815 Pacific Highway and 15 Help Street, Chatswood – Gateway Determination Report

Greater Sydney, Place and Infrastructure

April 2021

Department reference number: IRF21/274

Figure 12: Draft Willoughby LEP 2012 Maximum height of buildings map (source: Council)

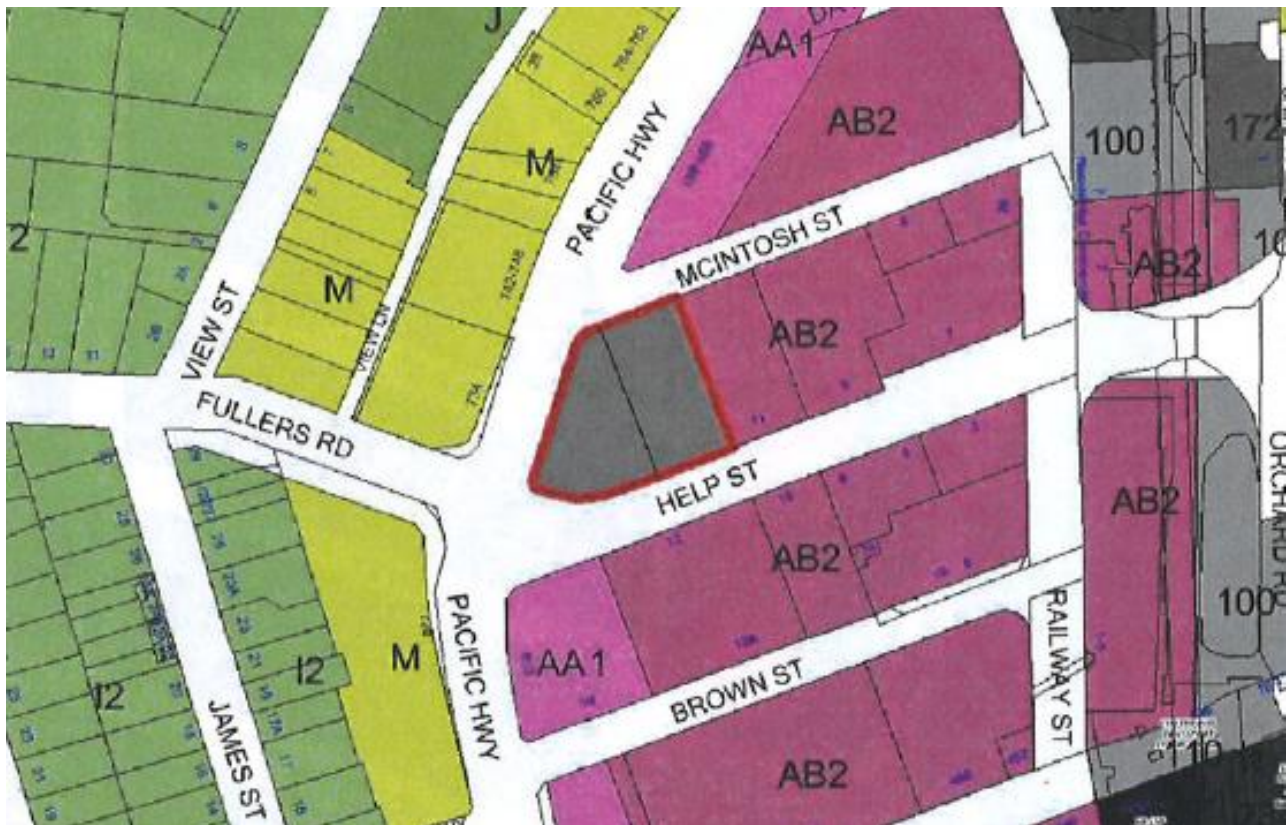
- an amended Maximum Height of Buildings Map (sheet HOB_004) (**Figure 12**);
- an amended Maximum FSR Map (sheet FSR_004) (**Figure 13**);
- an amended Lot Size Map (sheet LSZ_004) (**Figure 14**);
- an amended Special Provisions Area Map (SPA_004) (**Figure 15**); and
- an amended Active Street Frontages Map (ASF_004) by adding McIntosh Street and Pacific Highway (**Figure 16**).

All maps are to be updated to replace reference to 'Area X' with the nominated numerical or alphabetical identifier to indicate the applicable development controls in the relevant LEP clause, for example 'Area 8' (Clause 5.6 Architectural roof features) or 'Area 12' (Clause 6.23 Design excellence).

- (f) amend mapping to refer to the relevant area and replace 'Area X' with the intended nominated alphabetical indicator on the:
 - i. maximum HOB;
 - ii. maximum FSR map; and

Figure 24: Chatswood CBD Strategy proposed maximum height map (source: Willoughby City Council)

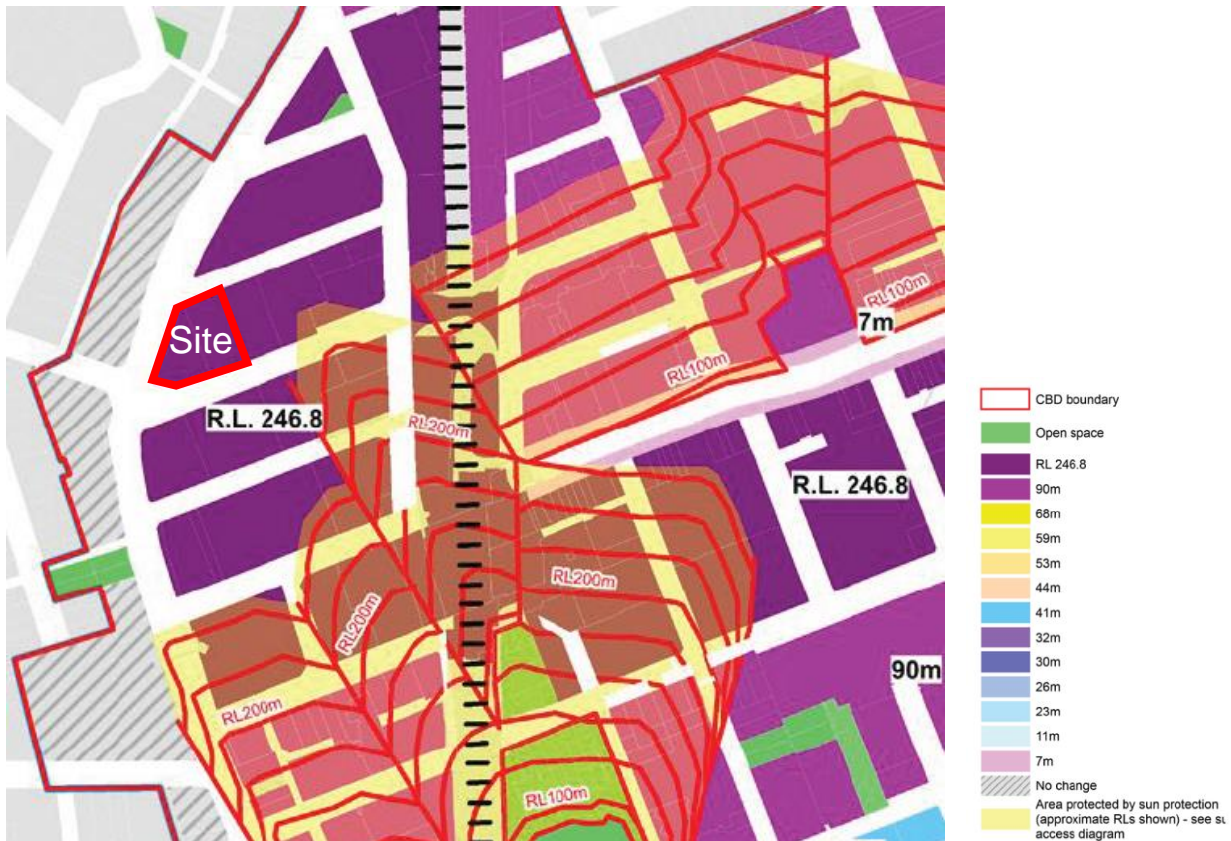
The concept design (**Figures 17-23**) for the proposal identifies that the development could achieve a maximum height of 142.8m (RL246.8m).

The proposed commercial tower is consistent with Council's desired maximum height of buildings for the site as recommended under the Chatswood CBD Strategy (**Figure 24**).

Figure 25: Proposed setbacks in the concept design (source: a+ Design Group)

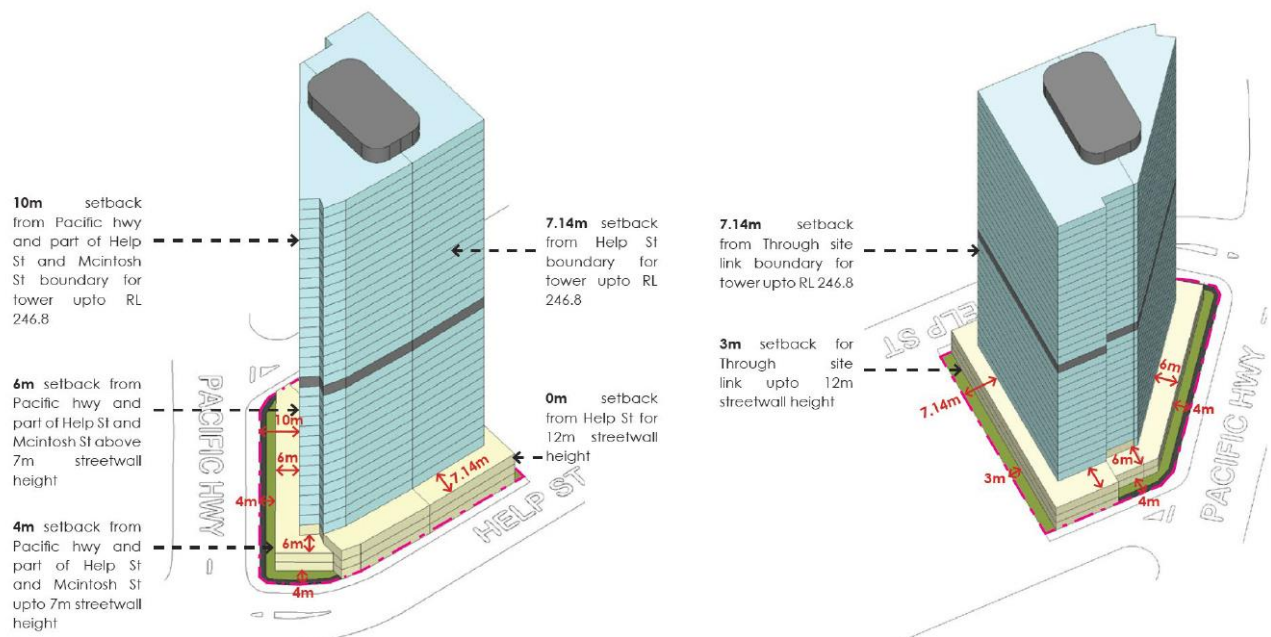
It is considered that the concept design demonstrates that sufficient building separation and setbacks can be achieved on the site under the proposed controls, subject to a detailed design at development application stage. The concept design in the planning proposal and Council's Detailed Assessment (**Attachment F1**) details that:

- the proposed building setbacks (**Figure 25**) are in accordance with the street frontage heights and building setbacks as outlined in the Chatswood CBD Strategy 2036;
 - ground level:
 - 4m to the Pacific Highway including the corners at McIntosh Street and Help Street;
 - no setbacks fronting McIntosh Street and Help Street;
 - 3m to the adjoining land to the east at 11 Help Street;
 - tower above podium:
 - 6m to the Pacific Highway including the corners at McIntosh Street and Help Street (total of 10m to the Pacific Highway including the corners at McIntosh Street and Help Street);
 - 7.14m fronting McIntosh Street and Help Street above the street wall; and
 - 7.14m to the adjoining land to the east at 11 Help Street (including a 3m ground setback).
